RUTH HARDING SCHOOL
 MODERNIZATION
 3201 PICO AVE.
 FOR
 BAKERSFIELD CITY SCHOOL DISTRICT
 BAKERSFIELD, KERN COUNTY, CALIFORNIA

ADDENDUM #01
RUTH HARDING SCHOOL
 MODERNIZATION
 BAKERSFIELD CITY SCHOOL DISTRICT
 BAKERSFIELD, CALIFORNIA

PARTIAL FLOOR PLAN-WING 300

B PARTIAL FLOOR PLAN - WING 300
 WING "300"
 PLAN NORTH

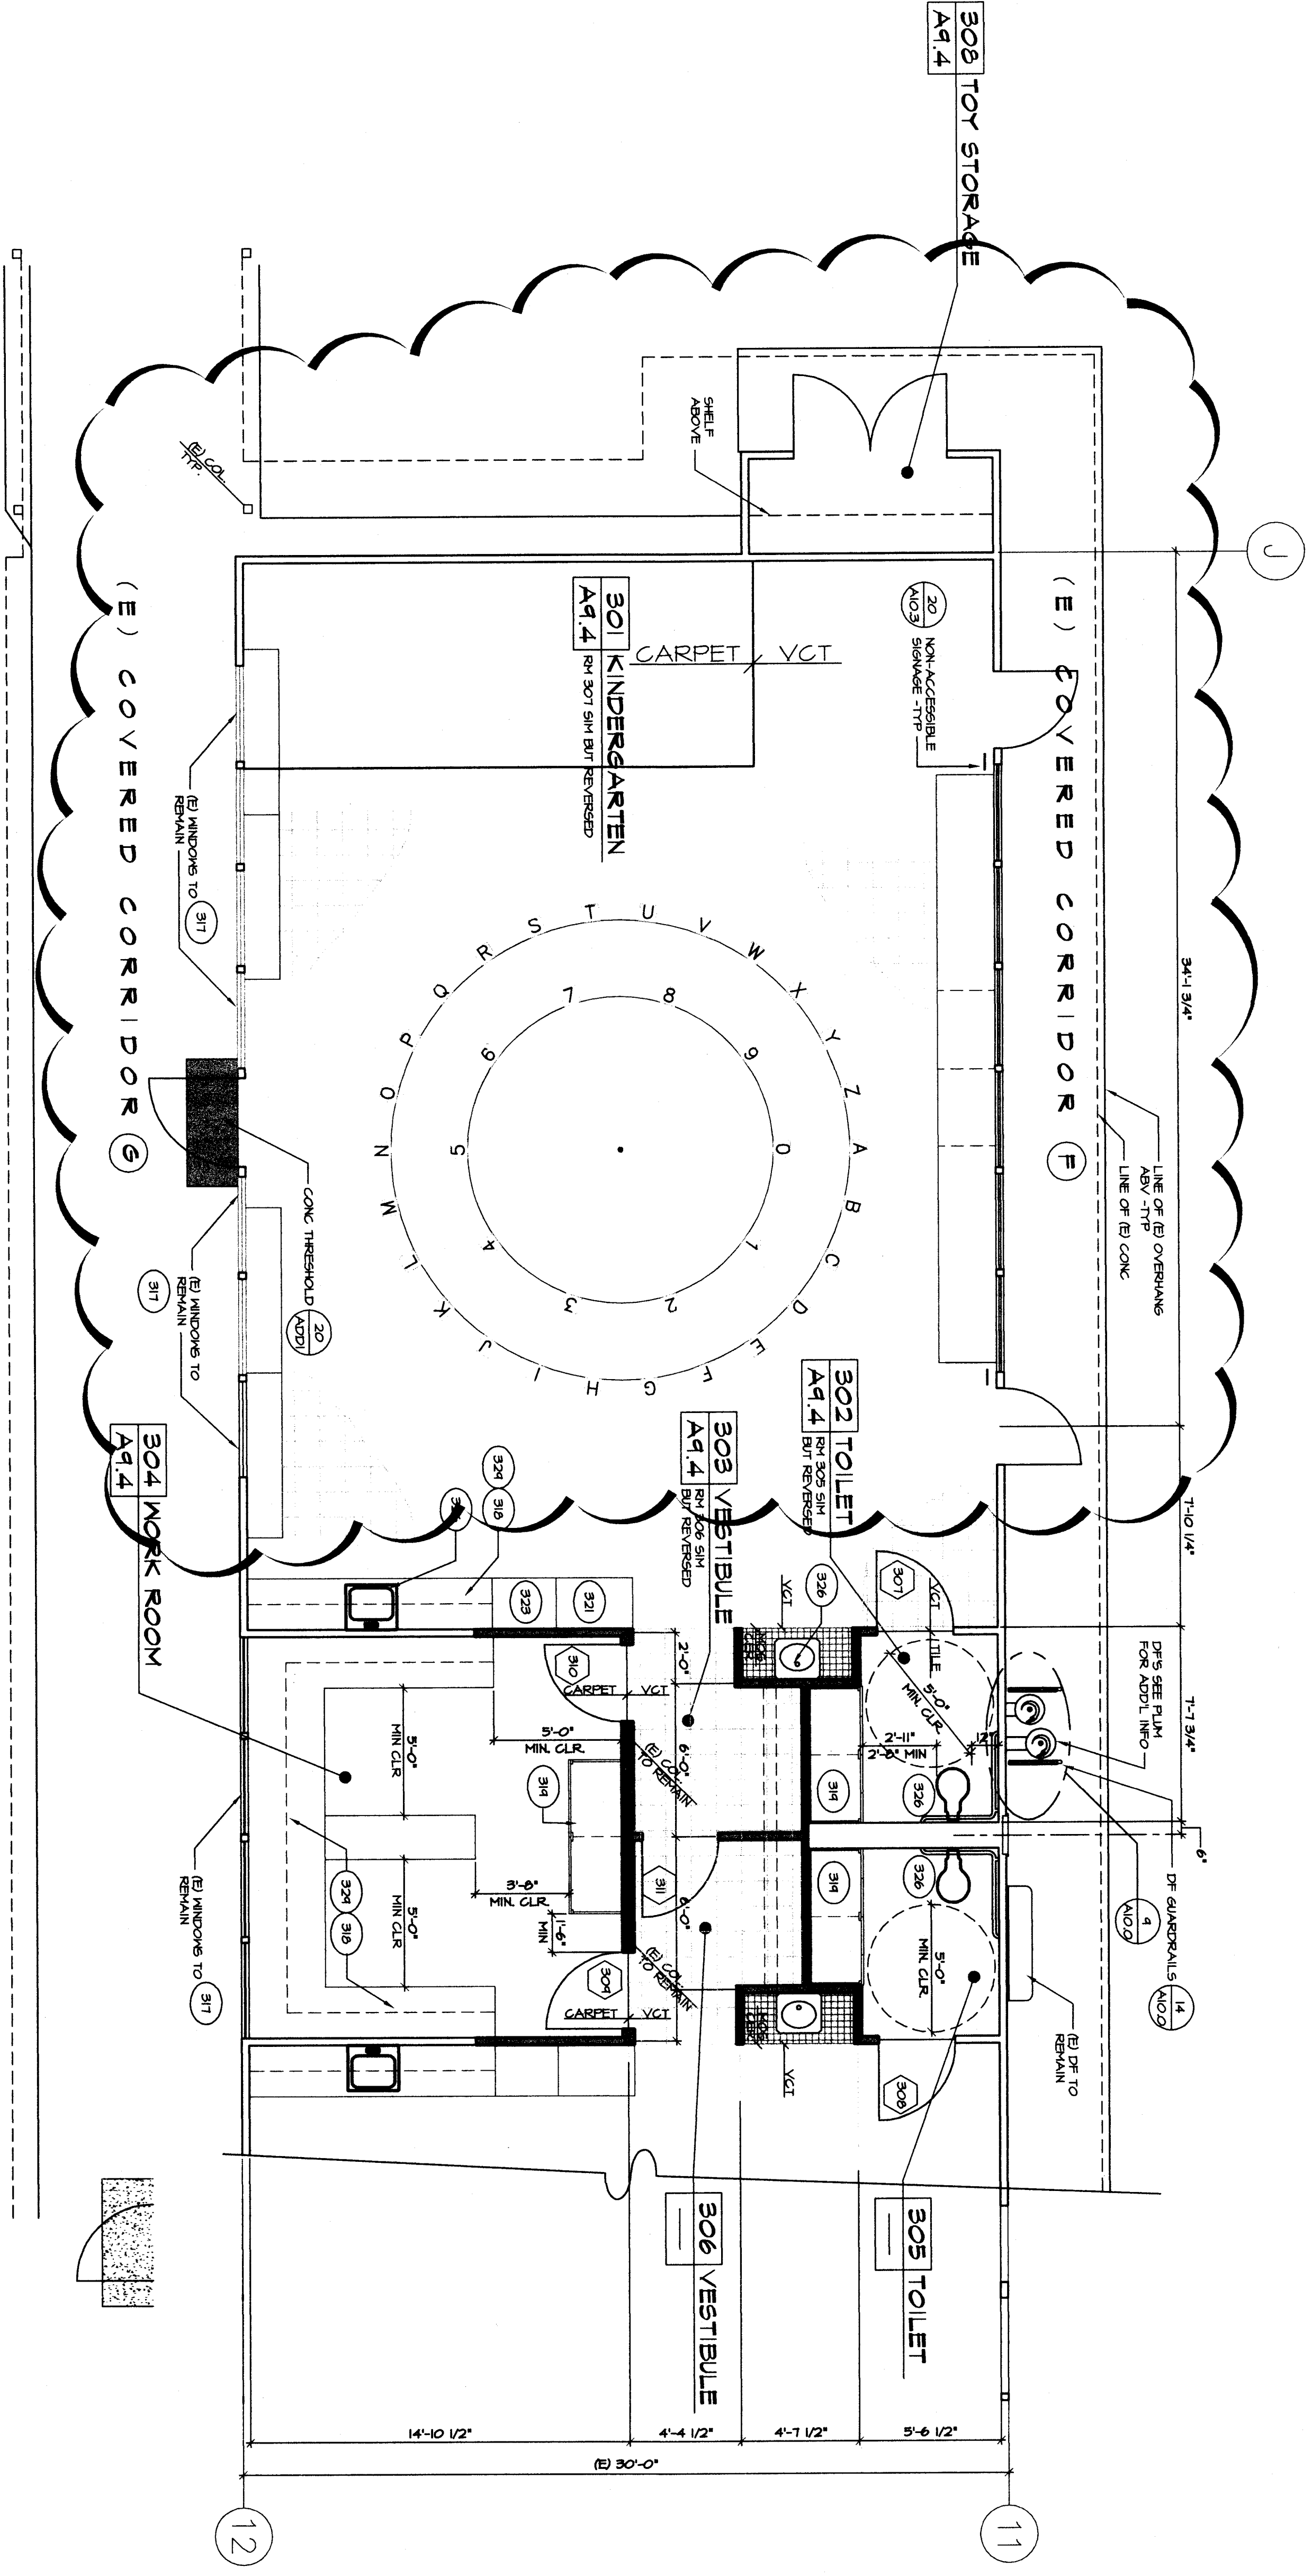
10. Refer to Drawings Sheet A3.1 Partial Floor Plan-Wing 300.
 a. DELETE
 b. ADD
